UNITED STATES
NUCLEAR REGULATORY COMMISSION
WASHINGTON, D. C. 20555

Docket Nos. 50-269
50-270
and 50-287

In our meeting on March 23, 1977, at the Jocassee Dam site near the Oconee Nuclear Station, we stated what we consider to be appropriate actions for Duke Power Company to take to allow us to evaluate the potential seismic hazard at the Jocassee Dam.

SHORT TERM REPORT

RECOMMENDED STATION LOCATIONS AT LAKE JOCASSEE

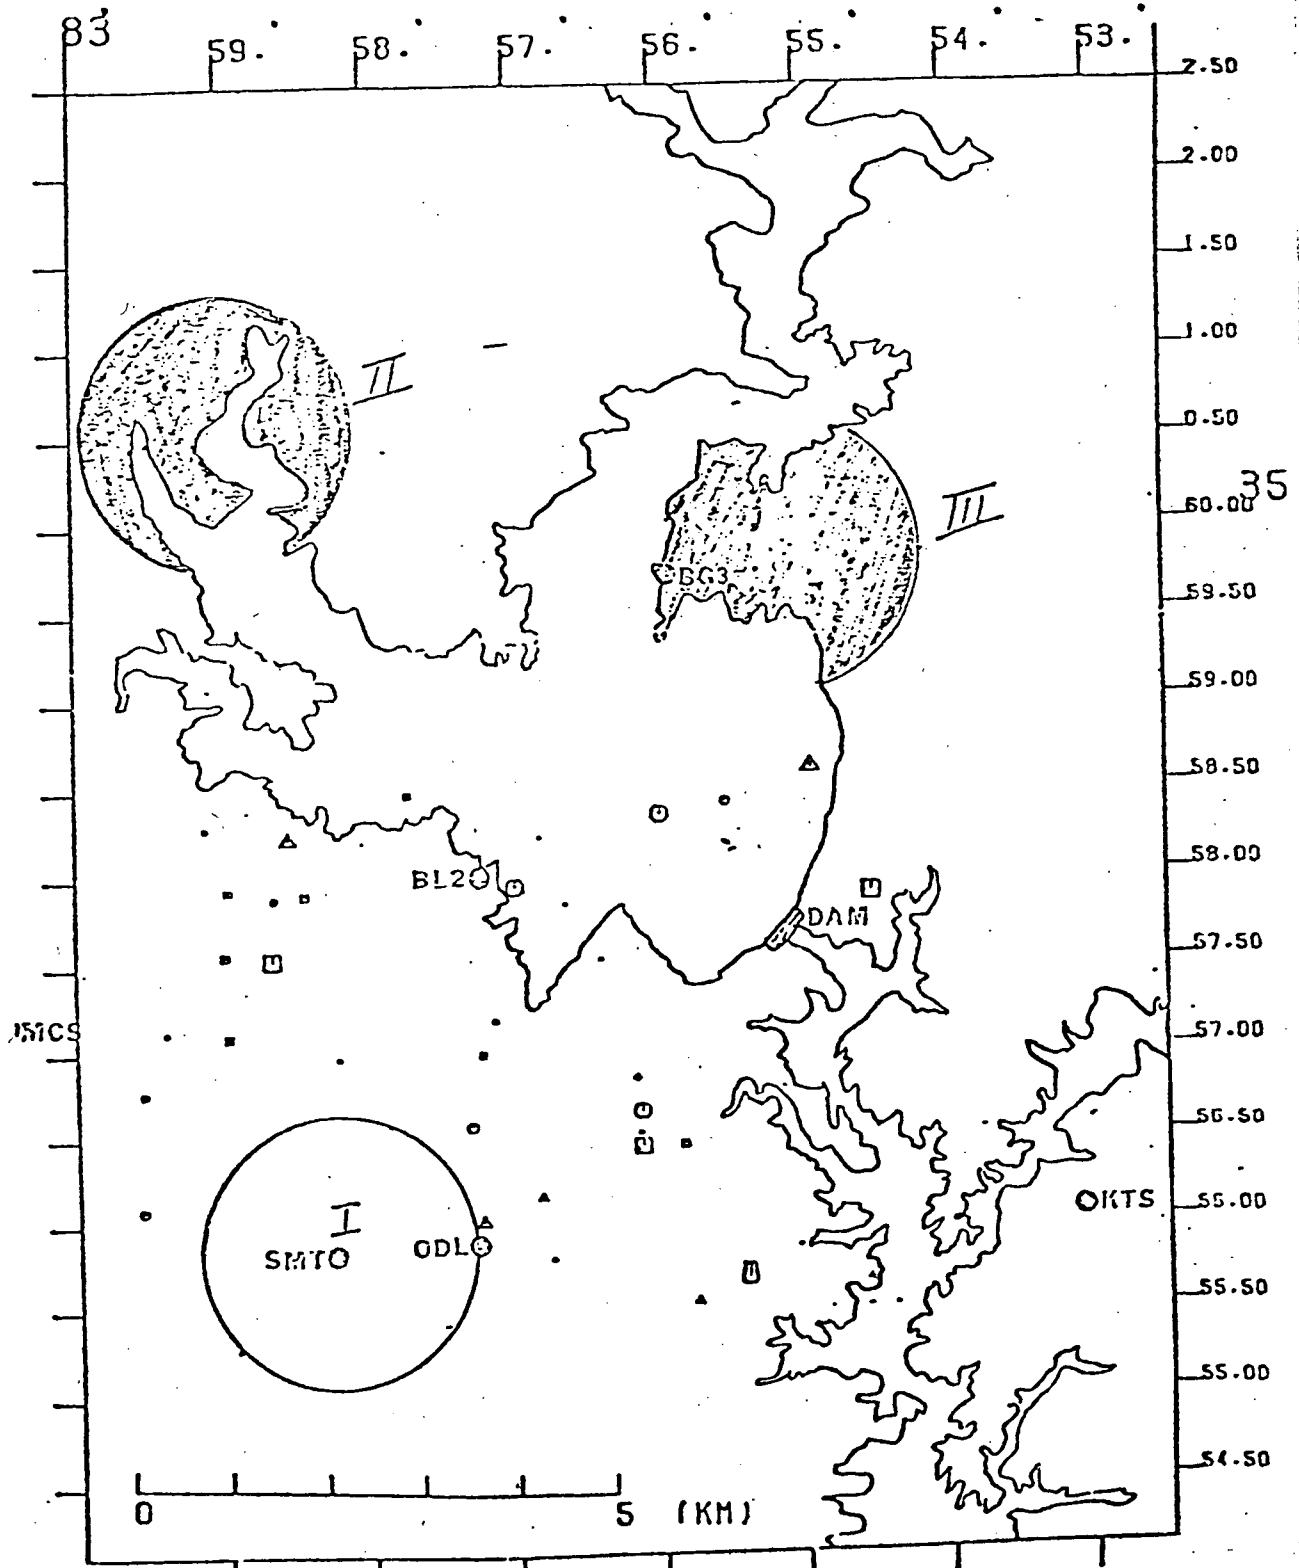
stations in addition to SMT should be installed as soon as possible. Suggested locations for these stations are shown in the attached figure. If possible, arrangements should be made with the USGS and USC to incorporate one or all of the Jocassee stations in the South Carolina network. This would allow recording of these stations on the develocorder at USC. If arrangements are made to include the stations in the network, it may be possible to use USGS radio frequencies for radio telemetry.
